B. ADDENDUM NO. 3

C. RFP #11-029

Date: November 14, 2011  
To: All Interested Parties  
From: Steve Gibson  
GRP Division Buyer

**SAN JACINTO RIVER  
AUTHORITY  
ADMINISTRATION BUILDING**

GRP BUILDING #1  
CIVIL  
CONCRETE HEADWALL W/FLARED WINGS  
AND RIPRAP LINING DETAIL

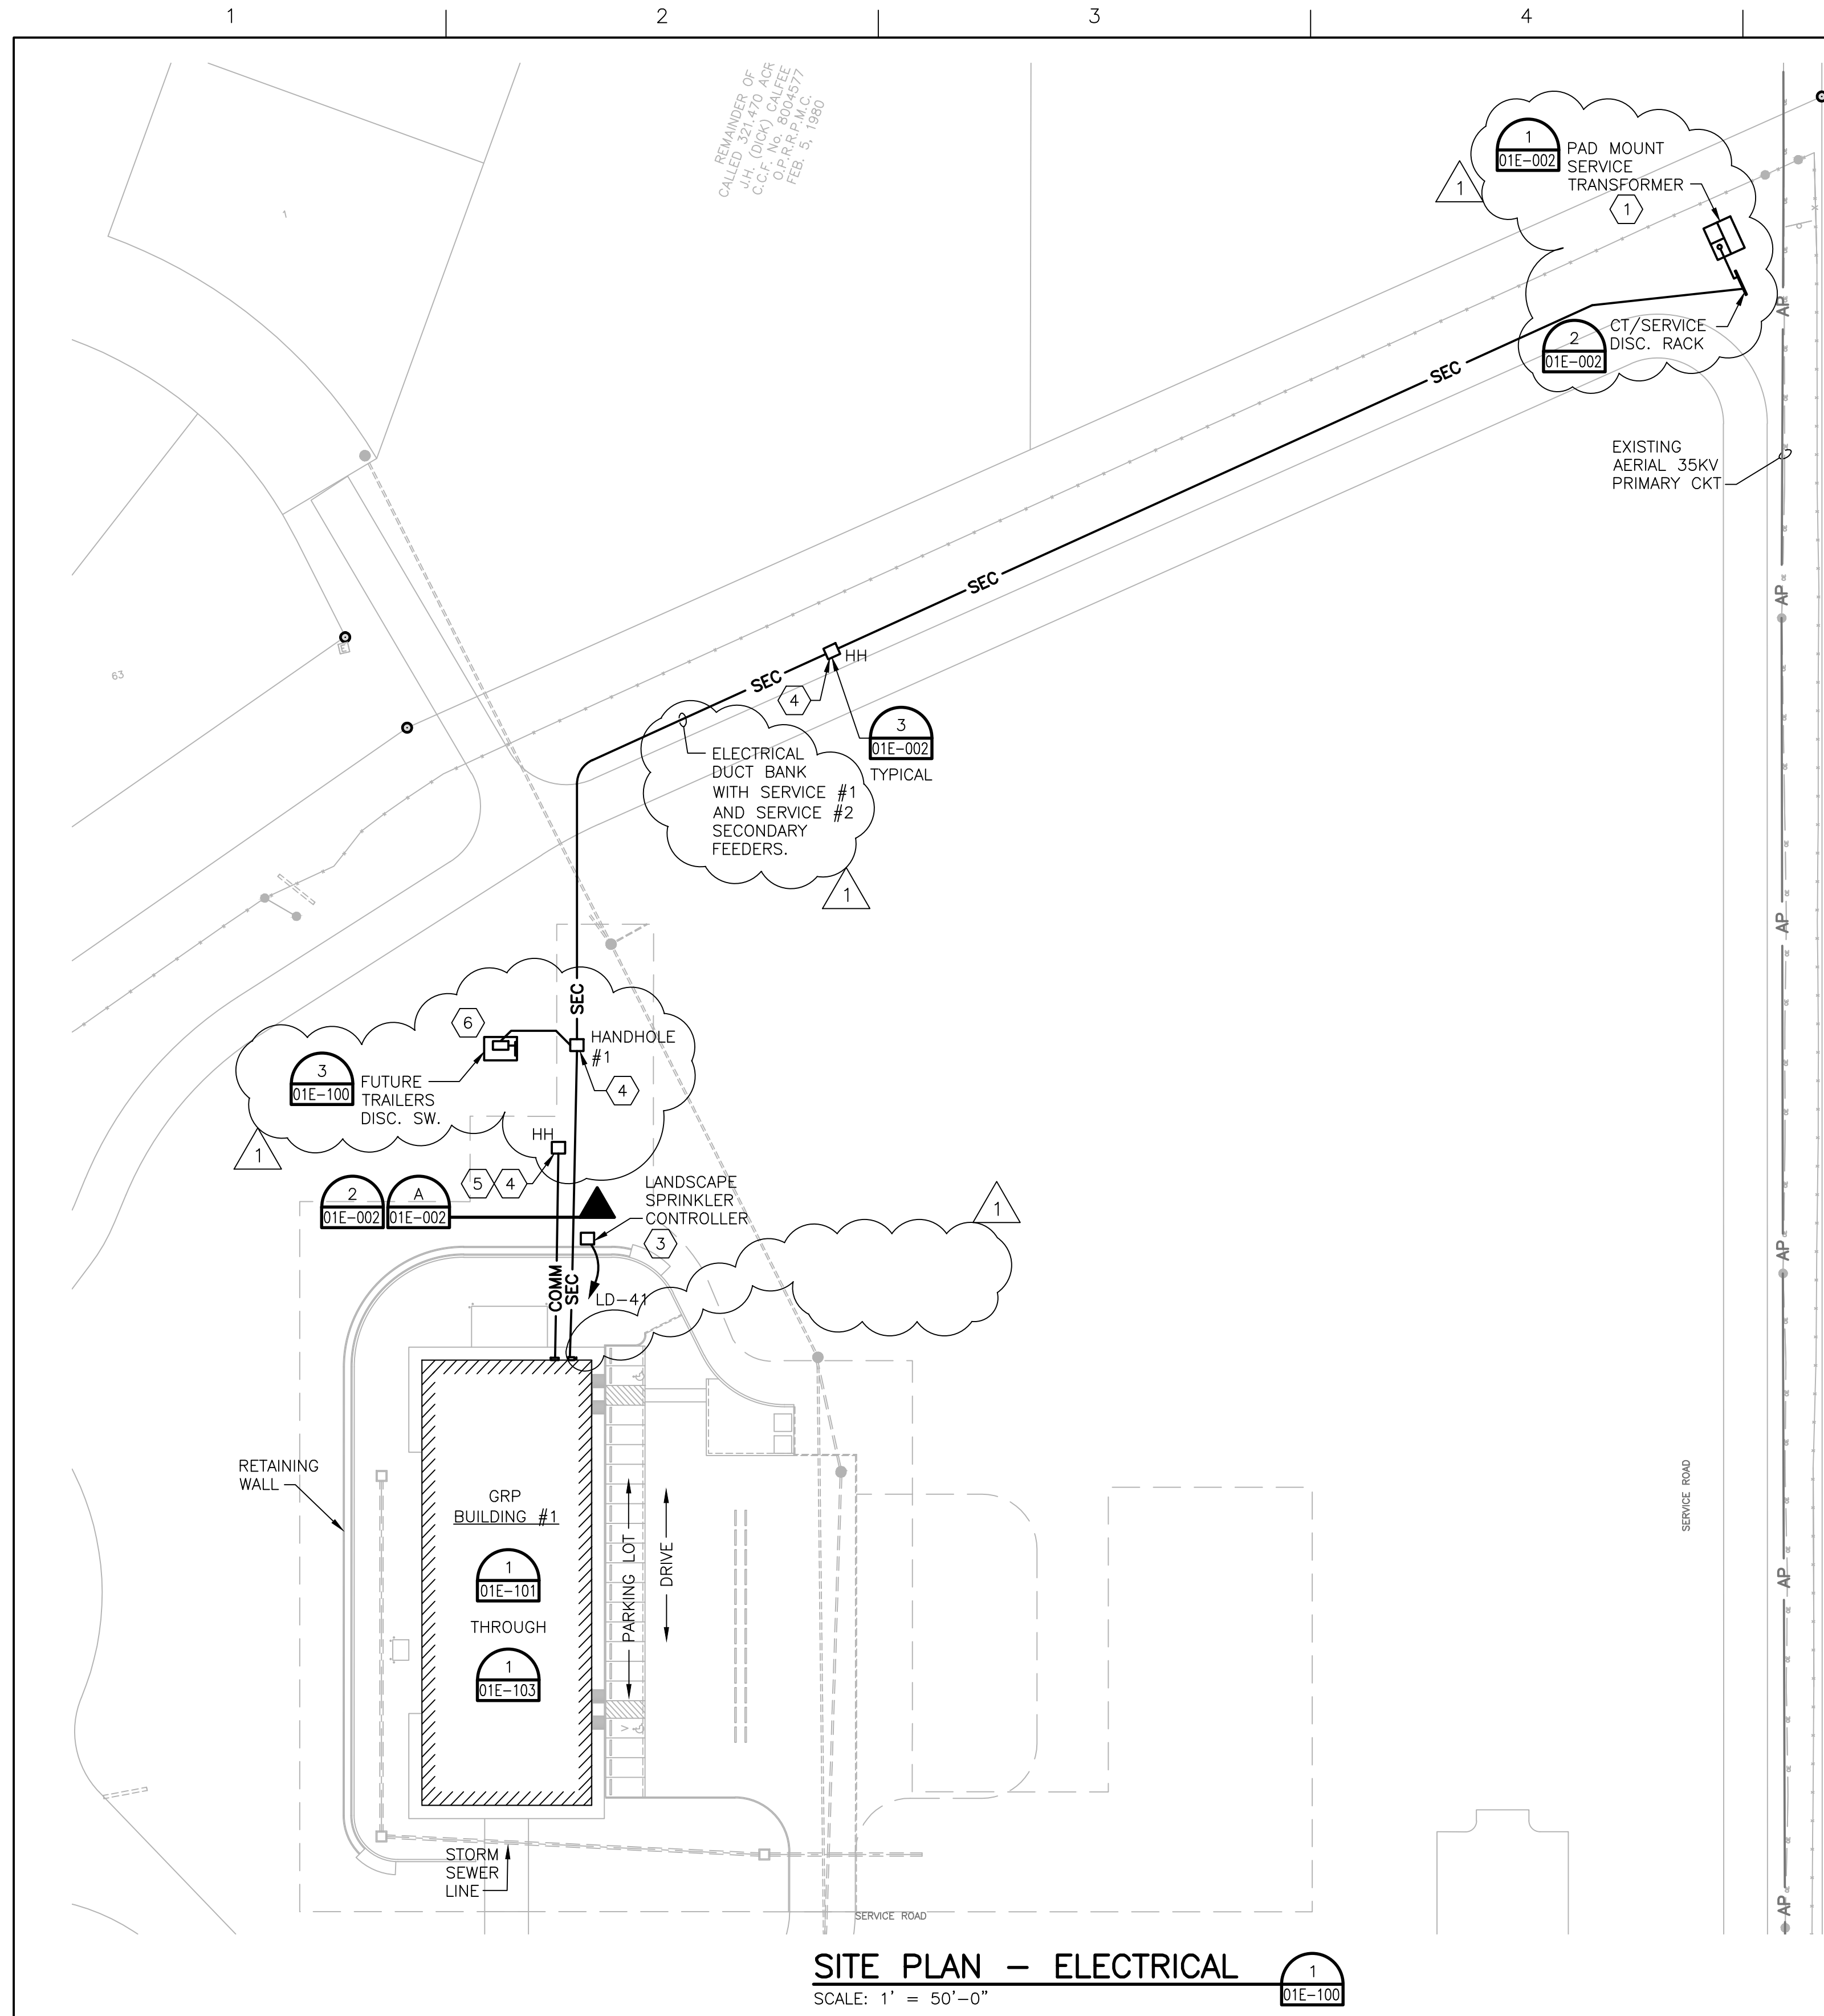
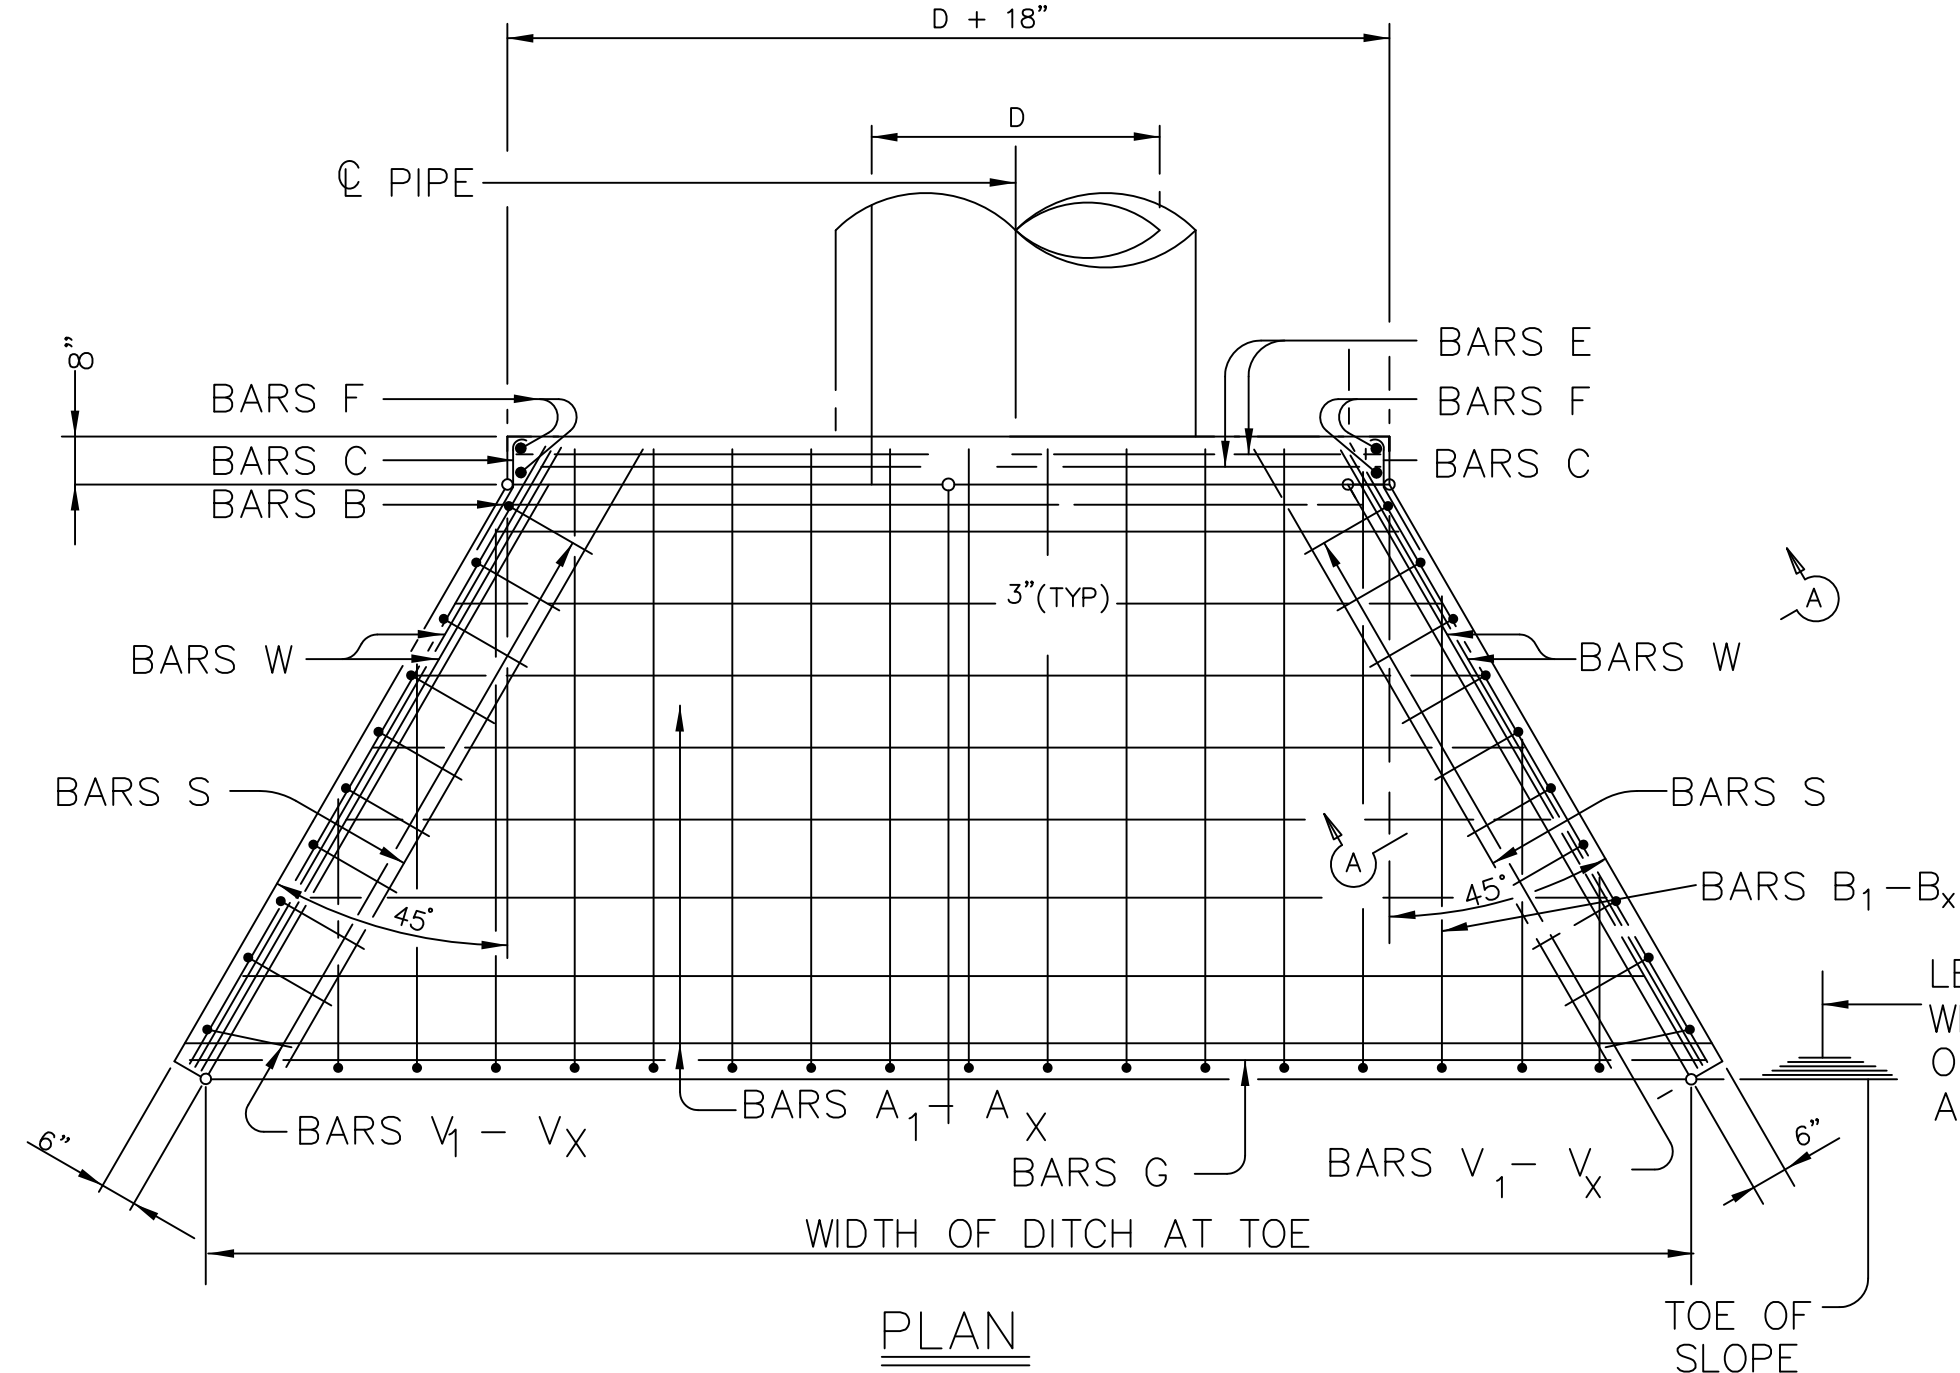
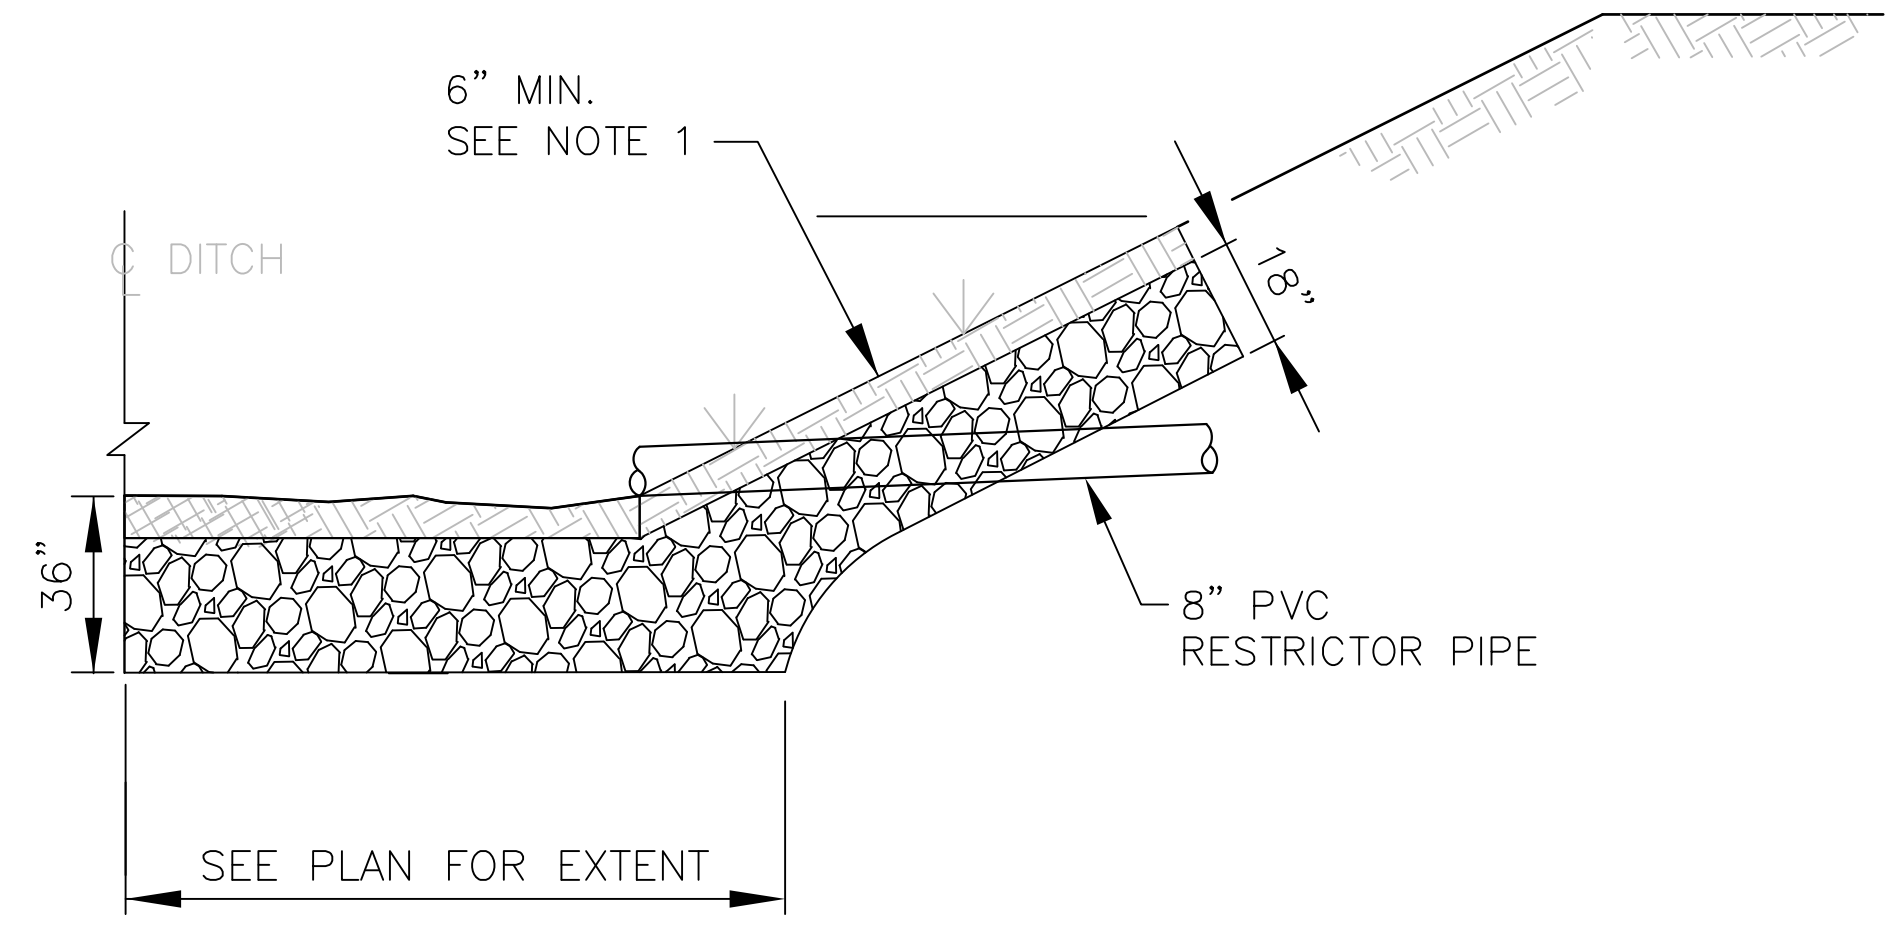
1. The revised sheet (01C-113) includes (1) the reference to the details for headwall and riprap in the callout revisions and (2) the horizontal control for the proposed detention swale. The new sheet (01C-114) contains the construction details for the proposed concrete headwall with flared wings and for the riprap where the proposed detention swale outfalls into the existing ditch.
2. Revised electrical sheets (01E-100, 01E-102 and 01E-600) issued for incorporation of 800A, 480V, 3-phase Service #2 (construction trailer power). This includes duct bank modifications as well as a pad mounted service transformer in lieu of the pole mounted transformer bank. This item No.2 only will be considered as an ADD ALTERNATE.
